Agreement No. CE 64/2021 (DS)
Drainage Improvement Works at North District (Phase 1)- Design and Construction

Drainage Improvement Works at San Tin Eastern Main Drainage Channel

Further Information (FI) for
Application for Permission under Section 16 of the Town Planning Ordinance
(A/YL-ST/628)

Further Information (FI) for
Application for Permission under Section 16 of the Town Planning Ordinance
(A/YL-ST/628)

Drawing Title
 SAN TIN EASTERN MAIN
 CHANNEL
 LANDSCAPE TYPICAL PLAN
 (SHEET 2)

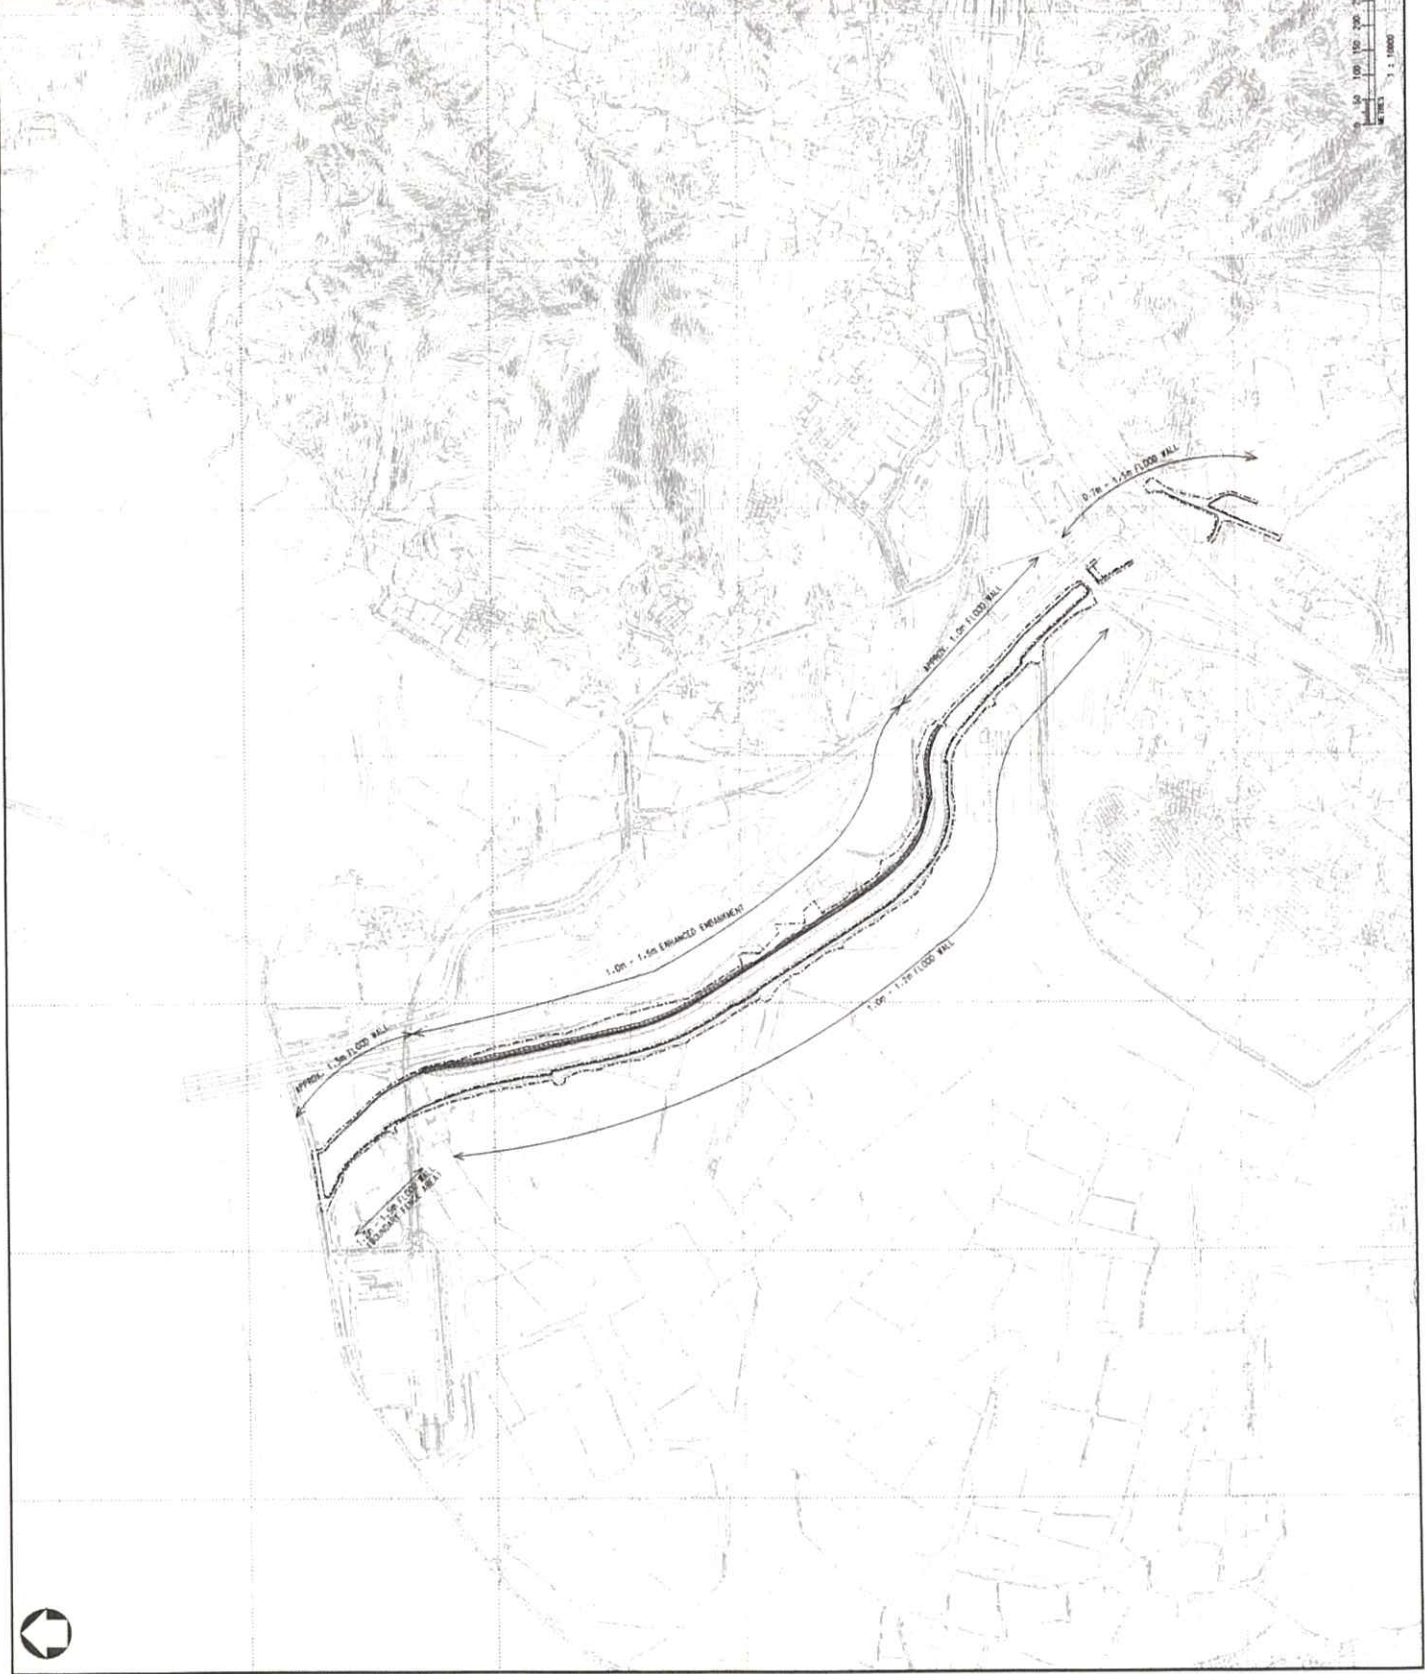
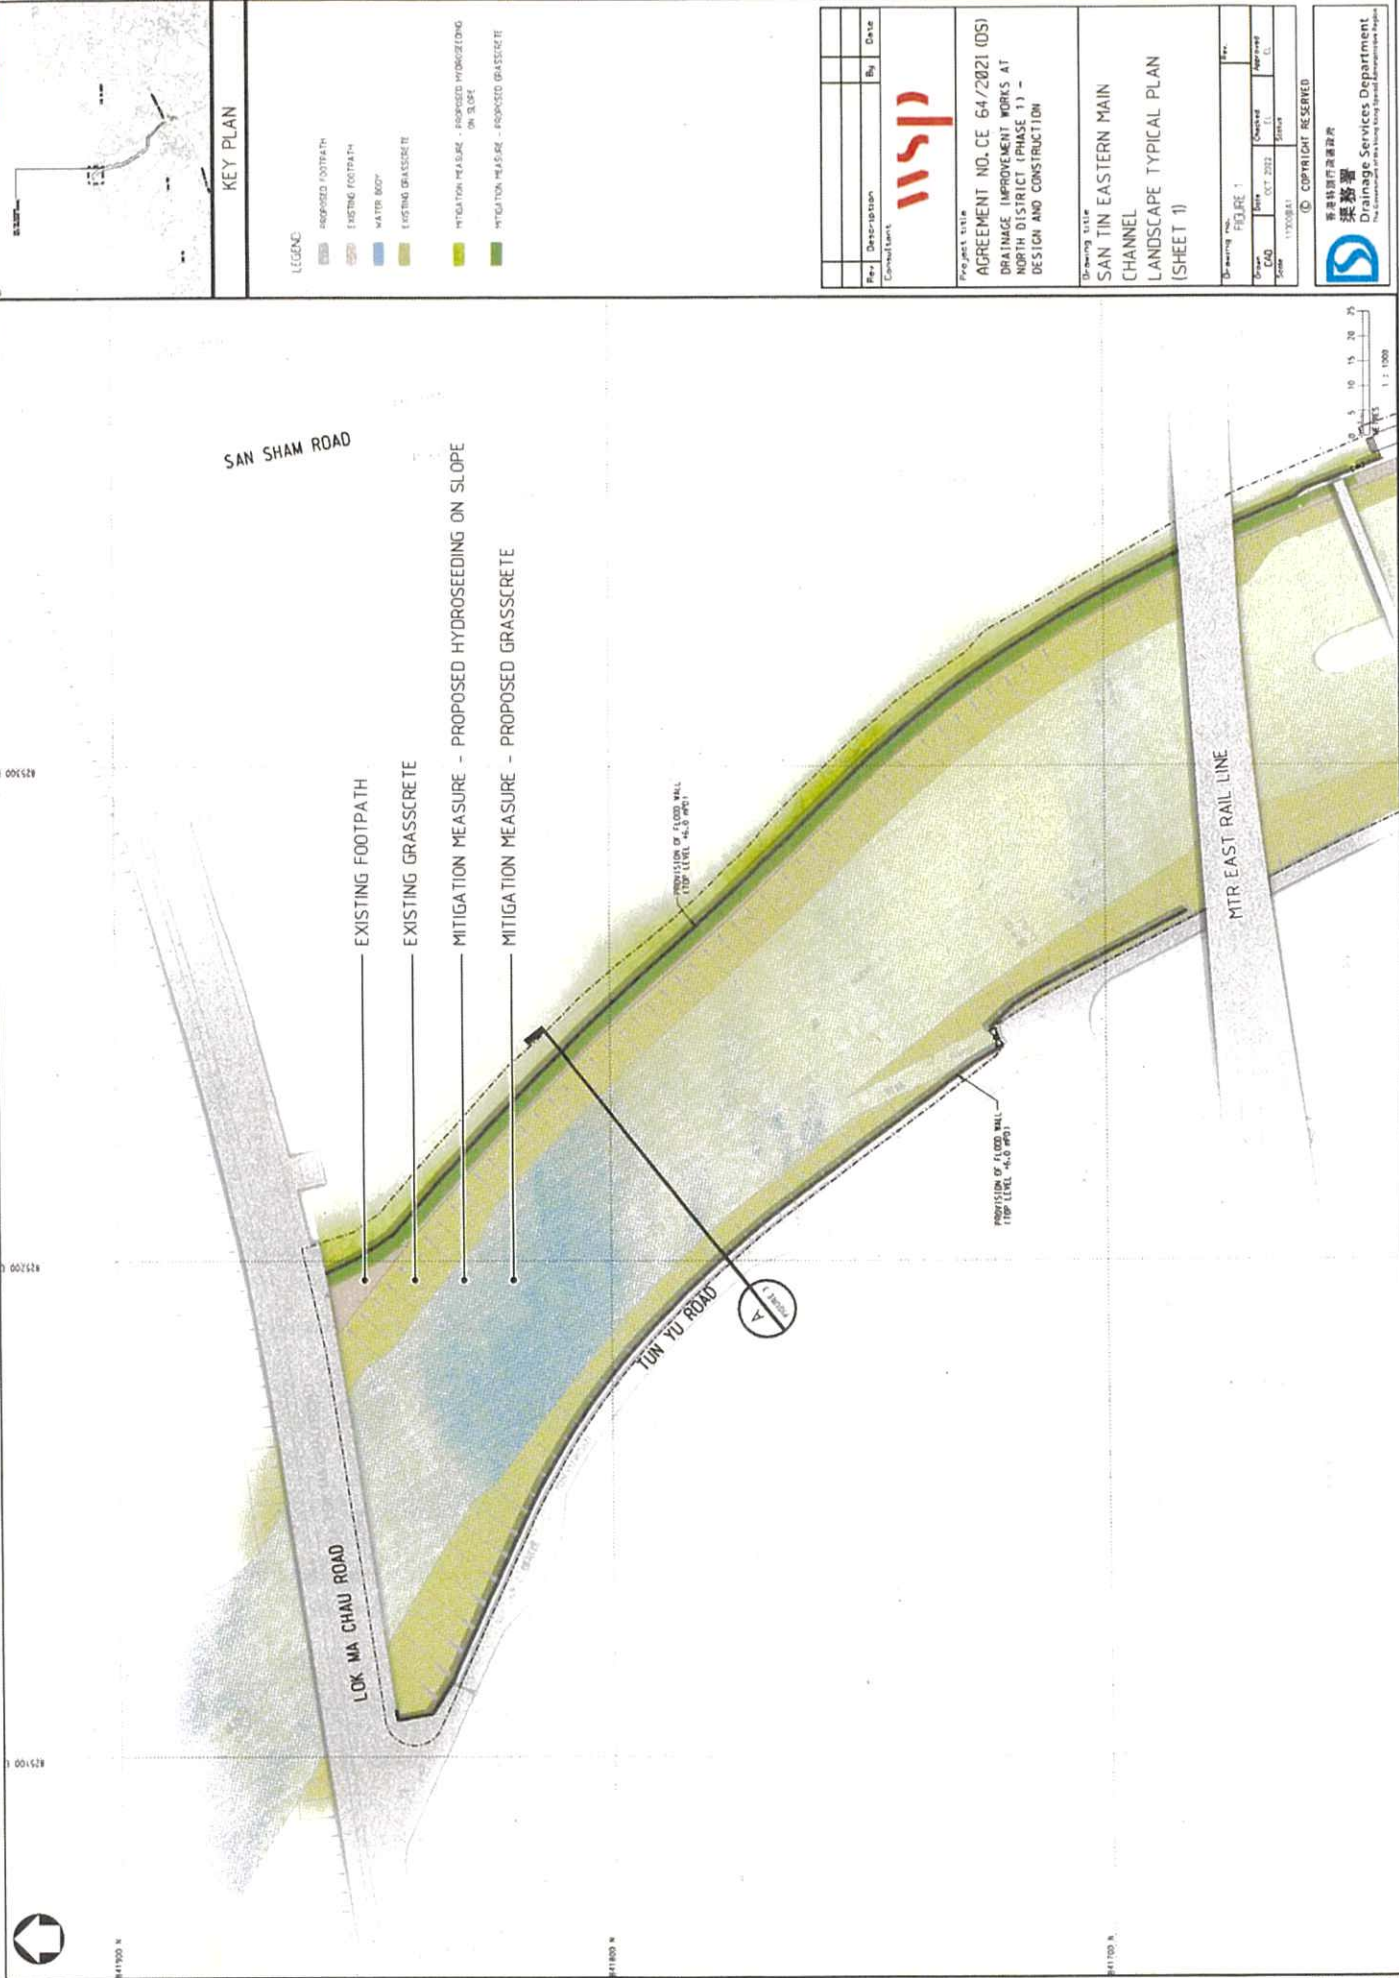
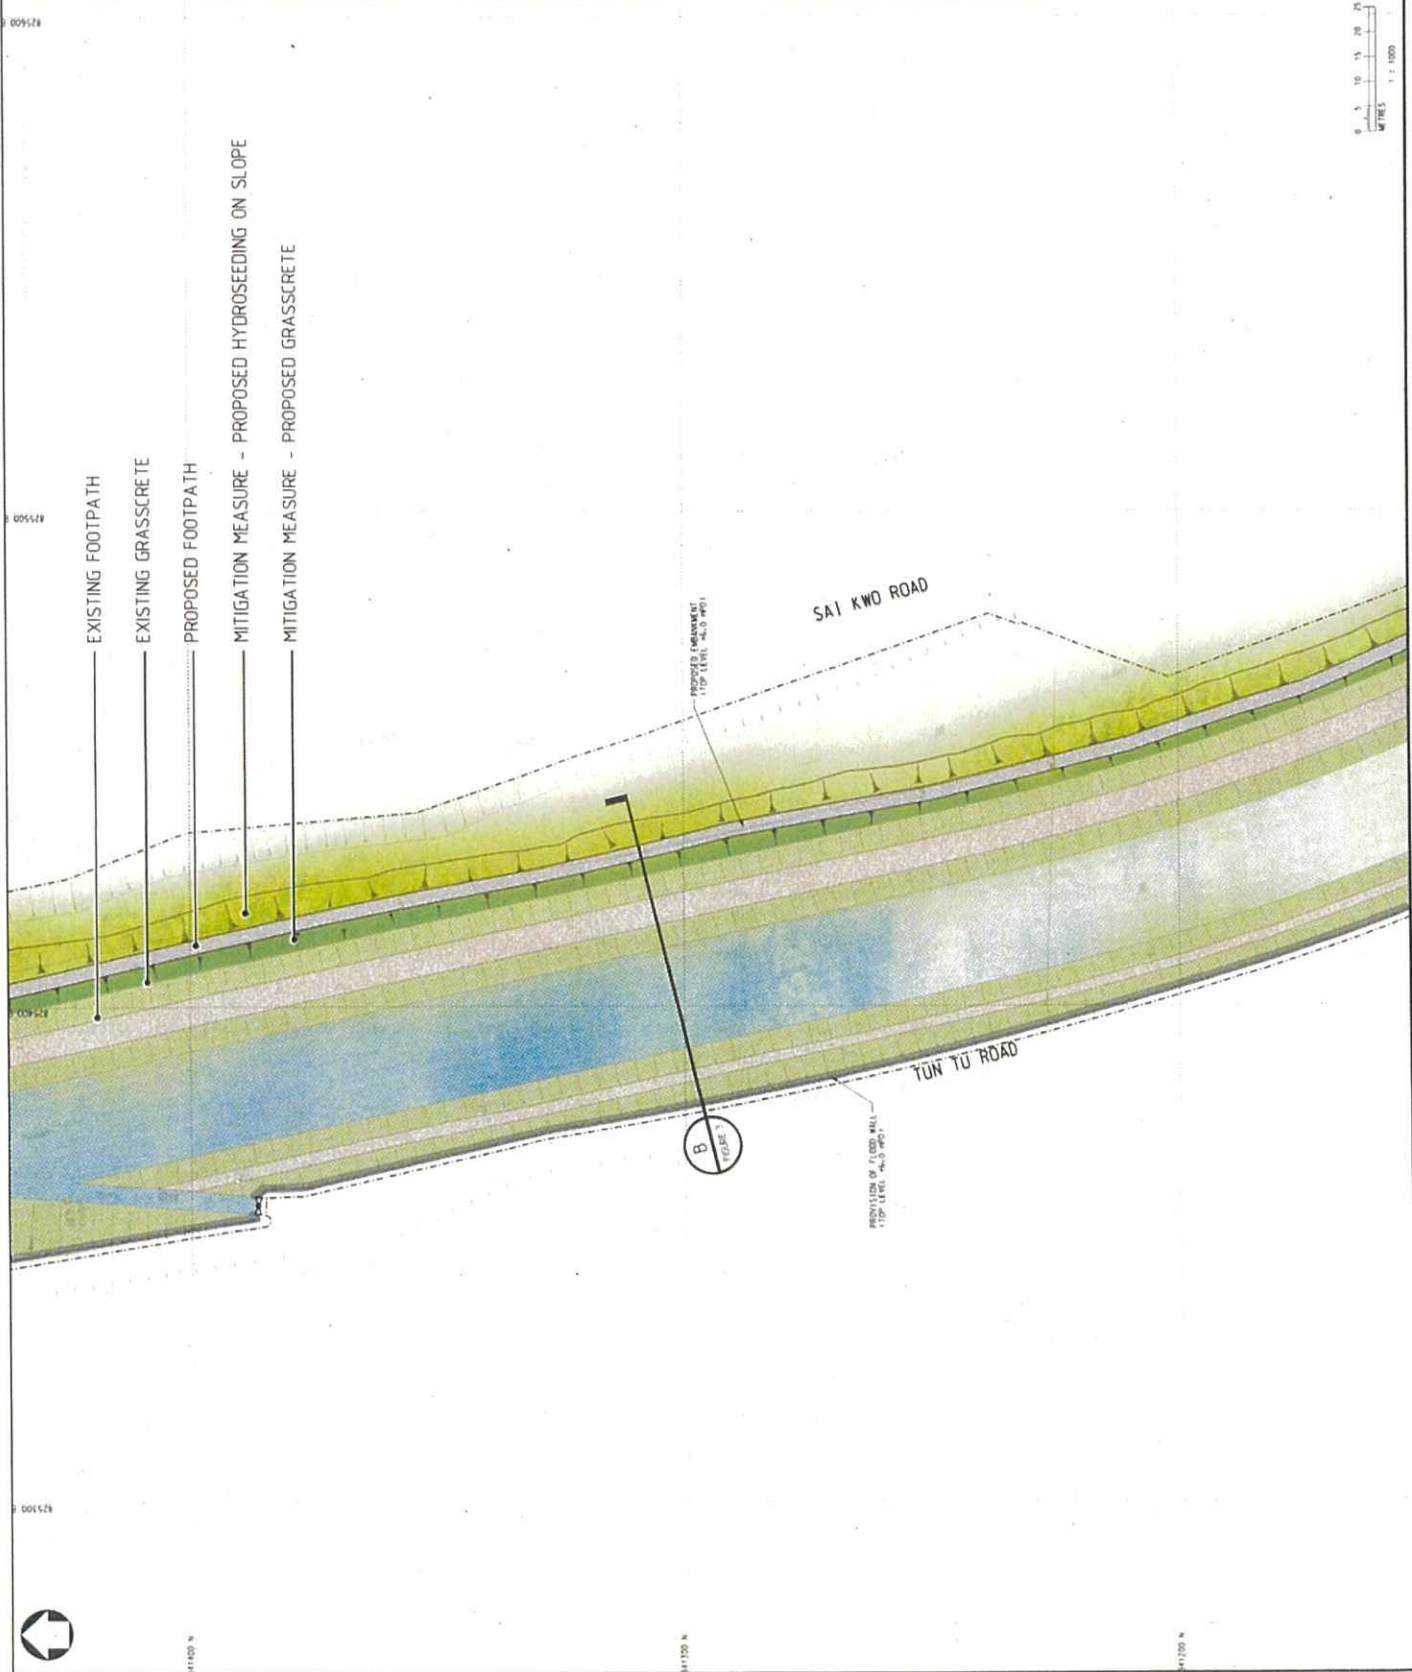
Item 5, prior to considering tree transplanting, justifications to demonstrate tree removal is unavoidable should be provided.	
	Item 6, it should be clarified whether T2124 is proposed to be retained or transplanted.	
	On Figures 1 & 2, "Mitigation Measure - Proposed Hydroseeding on Slope" (i.e. annotation and legend) is not consistent with "Proposed Hydroseeding/ Tree Planting" (i.e. annotation) on Figure 3 and should be suitably revised.	
	Figure 1, the annotations "Mitigation Measure - Proposed Hydroseeding on Slope" and "Mitigation Measure - Proposed Grasscrete" are pointed to the Nullah and should be rectified.	
3	Planning Department/ District Planning Branch New Territories District Planning Division DPO/FS&YLE's Email dated: 18 October 2022 Ms. Alice CHEUNG	
	Please clarify the details and the proposed drainage improvement works, including the proposed height of the floodwall and embankment, construction hours, construction period, etc., and all the mitigation measures to address any visual, ecological, environmental, drainage and other technical impacts with corresponding photos, section plans and drawings.	<ul style="list-style-type: none"> ● The proposed flood wall is from 0.7m to 1.5m in height. Most of the sections are 1.2m in height. The height of floodwall is illustrated in Drawing No. CE64/09/DIWI101 in Annex 1. ● The construction hours are from 7:00 a.m. to 7:00 p.m. No construction work will be carried out during birds' peak overwintering season from November to March in accordance with the Environmental Permit granted for the drainage improvement works. ● Enclosed please see photo taken in May 2022 for your reference (Annex 3). We intended to replace the type-II railing by a solid flood wall. Given
